Access Compliance Report

Public Rights-of-Way

Intersection ID: 17770	Main Street: LORENE_AV	Cross Street: ROSWELL_AV	Location: NE
ADA ID: 81DCC093C7A1	Ramp Type: Directional1	Initial Pass/Fail: Fail	Overall Compliance: No
		Severity Score: 37.5

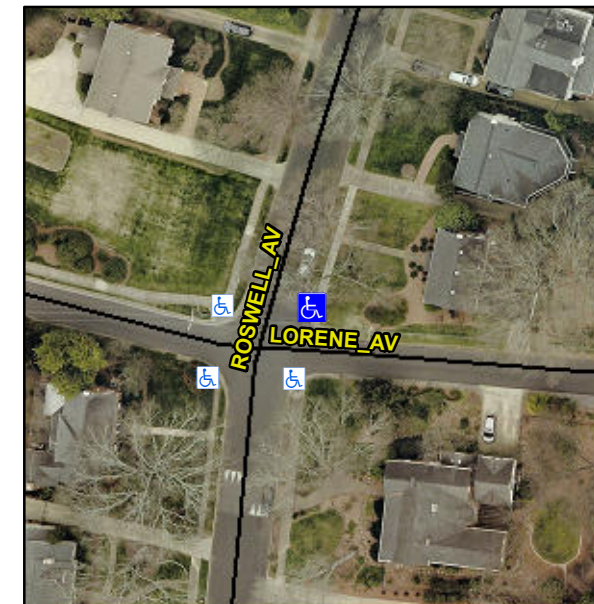
ASP LIP 1.0"

R304.2.2, R304.5.3

Compliance	Description	Data	Compliance	Description	Data
N/A	Ramp Length (in)	63.0	N/A	Grade Break?	N/A
Yes	Ramp Width (in)	53.0	N/A	Grade Break Slope (%)	0.0
No	Ramp Slope (%)	12.2	N/A	Grade Break XSlope (%)	0.0
No	Ramp XSlope (%)	5.5			
N/A	Flare Type LT	N/A	N/A	Flare Type RT	N/A
N/A	Flare Slope LT (%)	N/A	N/A	Flare Slope RT (%)	0.0
N/A	Flare Traversable LT?	N/A	N/A	Flare Traversable RT?	N/A
N/A	Landing Length (in)	0.0	N/A	DWS Provided?	N/A
N/A	Landing Width (in)	0.0	N/A	DWS Contrast?	N/A
N/A	Landing Slope (%)	0.0	N/A	DWS Length (in)	N/A
N/A	Landing X Slope (%)	0.0	N/A	DWS Full Width?	N/A
N/A	Landing Curb? (Y/N)	N/A	N/A	DWS Offset LT (in)	N/A
N/A	Shared Landing?	N/A	N/A	DWS Offset RT (in)	N/A
N/A	Gutter Ponding?	0.0	N/A	Gutter Slope (%)	N/A
N/A	Gutter Lip Ht (in)	0.0	N/A	Gutter X Slope (%)	N/A
N/A	Painted X Walk1?	No		Road Slope (%)	0.2
	X Walk 1 Direction	To S		Road X Slope (%)	2.4
	X Walk 1 Width (in)	N/A		Clear Space?	N/A

Remove & Replace Entire Ramp.
